Subject: Issuance of Amendment Nos. 139 and 76 to Facility Operating Licenses  
DPR-57 and NPF-5 - Edwin I. Hatch Nuclear Plant, Units 1 and 2  
(TACS 64779/64780)

The amendments modify the Technical Specifications related to scram speed limit, scram speed measurement requirements, definition of design power, minimum critical power ratio limit, lead test fuel assemblies, and the average planar linear heat generation rate limits curve.

SAFETY EVALUATION BY THE OFFICE OF NUCLEAR REACTOR REGULATION

EDWIN I. HATCH NUCLEAR PLANT, UNITS 1 AND 2

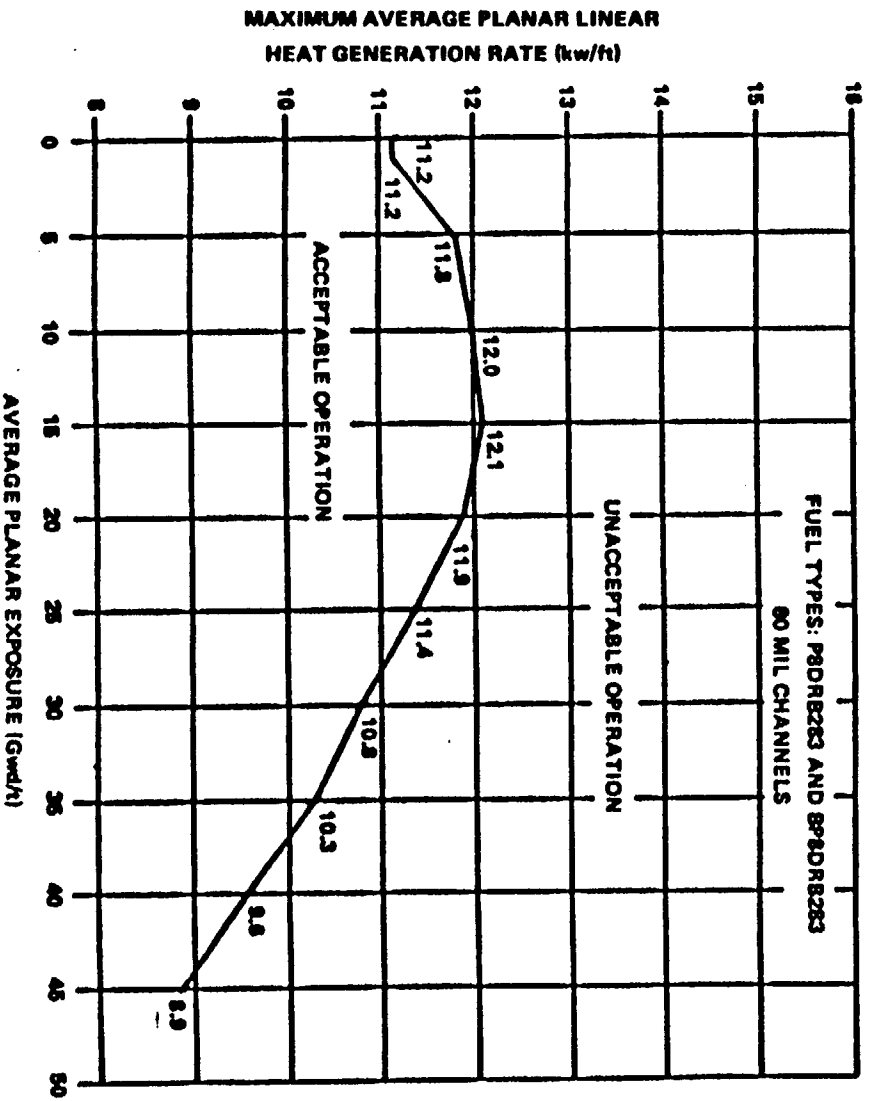
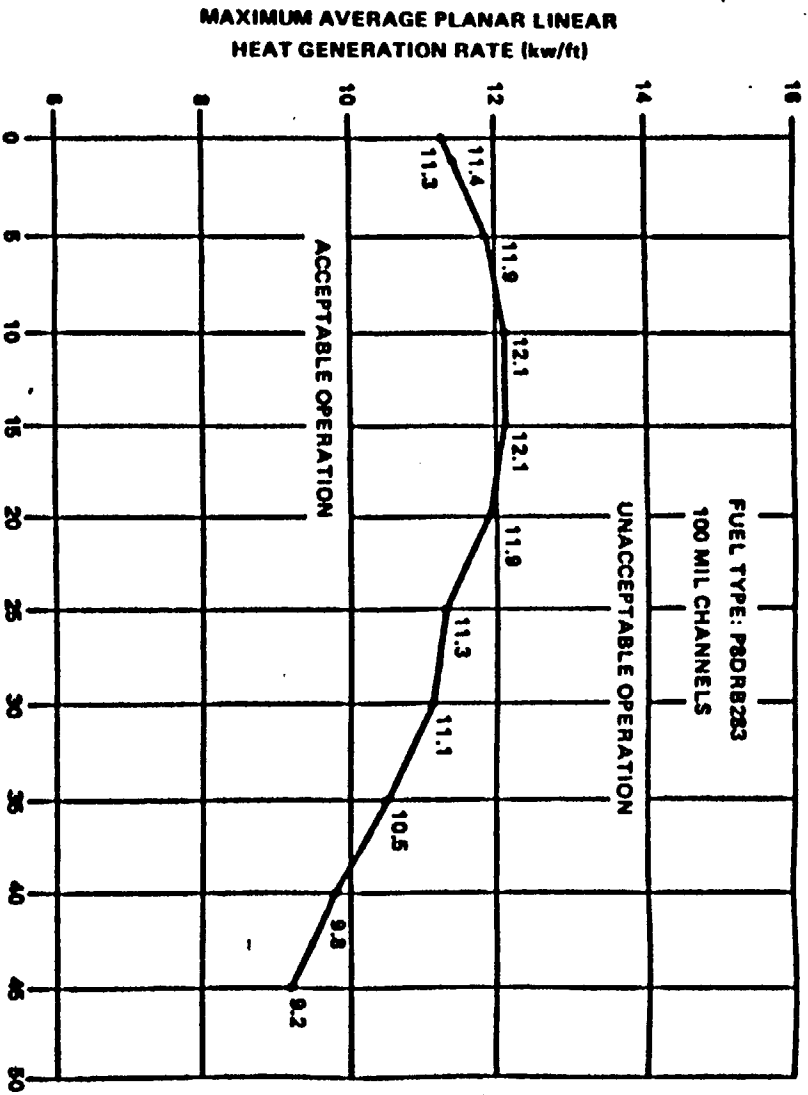
The licensee proposes to add to Unit 1 TS Figure 3.11-1 (Sheet 6) a new curve showing the maximum APLHGR (MAPLHGR) as a function of burnup for the LTA fuel type expected to be inserted (four assemblies) in the Reload 10 fuel batch. The fuel assembly is similar to LTA fuel recently approved by the staff for insertion (in limited amounts) in other reactors, e.g., Peach Bottom 2, Cycle 8. It is described in reports by GE, included as part of the Hatch submittal. These reports also describe the standard GESTAR II (NEDE-24011-P-A-8, "General Electric Standard Application for Reactor Fuel") methods which will be used to analyze the transients and accidents required to demonstrate that the LTA will operate within all design and safety limits. The LOCA analyses for the LTA in Hatch Unit 1, which provided the MAPLHGR values, were done on an assumed 14.4 Kw/ft LHGR limit, as has been approved for other reactors for this type of LTA fuel, but the operating limit in Hatch Unit 1 will remain at 13.4 Kw/ft; thus, no TS change for LHGR is needed for the LTA in Hatch Unit 1. Also, unlike more complex TS provided for some previously approved similar LTA fuel, a single MAPLHGR curve will apply to all axial regions of the assembly. The analyses providing the LTA MAPLHGR values and the resulting proposed curve, and the descriptions, fuel analyses, and proposed analyses for operation with the fuel in Hatch Unit 1 are acceptable.

The licensee proposes to add a MAPLHGR data point at an exposure of 1.0 Gwd/t to the curves for two existing fuel types, P8 DRB 283 and BP8 DRB 283 with 80-mil channels, (Figure 3.11-1 (Sheet 5) for Hatch Unit 1 and Figure 3.2.1-10 for Hatch Unit 2), which had been inadvertently omitted. These are data points from the original GE analysis and their addition to the TS figures is acceptable.

**FIGURE 3.11-4**  
**MCPR LIMIT FOR ALL 8X8 FUEL TYPES**  
**FOR RATED POWER AND RATED FLOW**

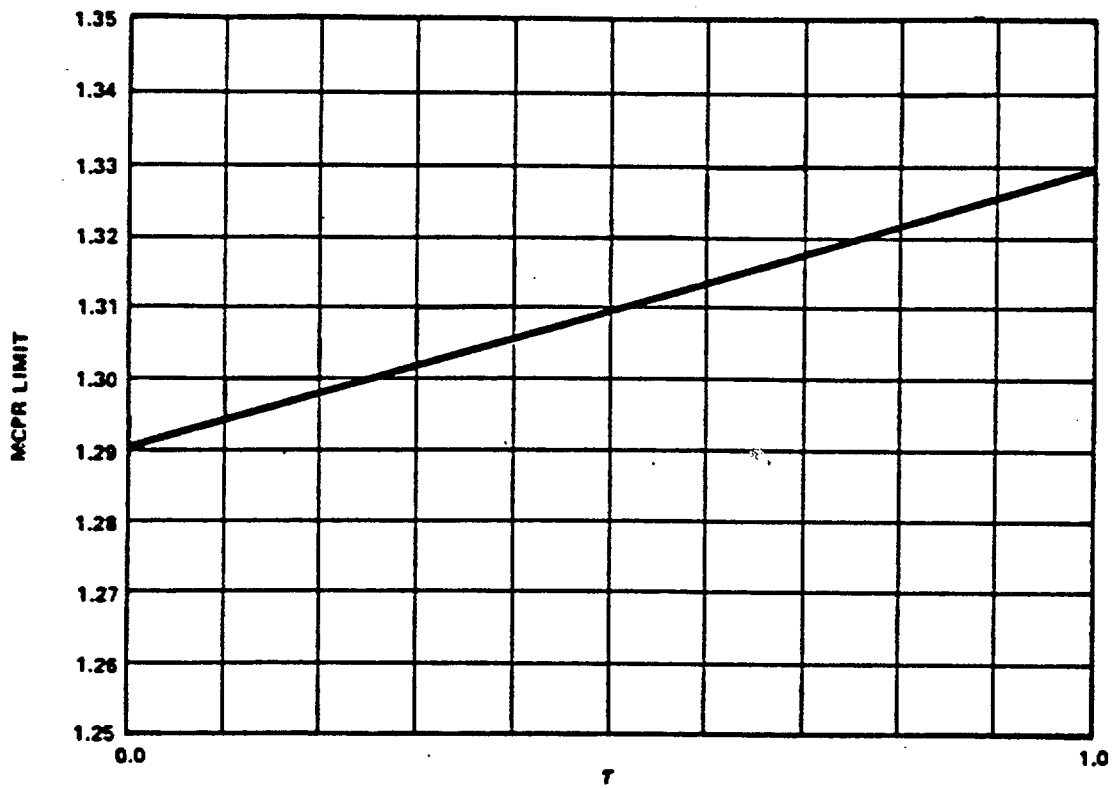
TS Figure 3.11-4 presents a curve of MCPR limits as a function of average measured scram speed (ODYN Code, Option A and B) for all 8 x 8 fuel types. The licensee proposes to reduce the Option A MCPR limit from 1.35 to 1.33 (thereby changing the curve in Figure 3.11-4) as a result of a change from the GENISIS to the GEMINI methods and uncertainty analysis. The GEMINI method is approved by the staff and the proposed change in MCPR limit for Option A scram speed is reasonable and acceptable.
